Application for Certificate of Appropriateness

Address of Subject Property: 1080 Clifton Road NE, Atlanta, GA 30307

Review of Structural Assessment Reports

STRUCTURAL ASSESSMENT

Photo 39

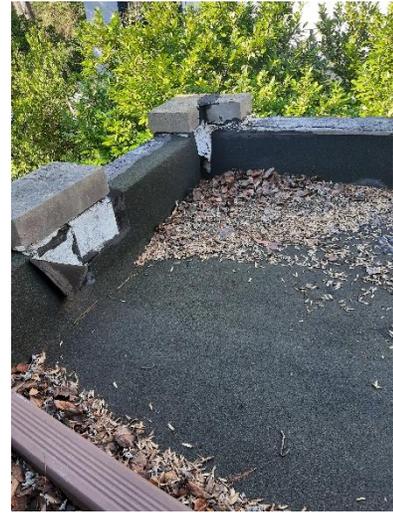
- g. Sunroom / Enclosed Porch
 - i. This area shows the most damage to the structure.
 - ii. The roof over the Sunroom / Enclosed Porch shows extensive signs of water intrusion with damaged and rotten roof joists. The framing over the window on the north side is damaged and rotten with mold growing. See Photos **39 through 42**.

1. Sykes does not believe that this house is unable to be rehabilitated from a strictly structural point of view.
 - a. The sunroom / enclosed porch above the basement level is the portion of the house that will require the most demolition / rebuilding.

- i. Roof over sunroom would need to be completely redone. There is significant damage to the wood where the roof has leaked
 - b. Sykes recommends a roof assessment for main building. The corner of the roof over the private bathroom on the second floor and the breakfast nook on the first floor shows signs of significant water leaks. This low slope portion of the high roof does not appear to have the typical clay tile that was observed on the rest of the high roof. Damage to the framing from water leaks was also observed at framing near the chimney.
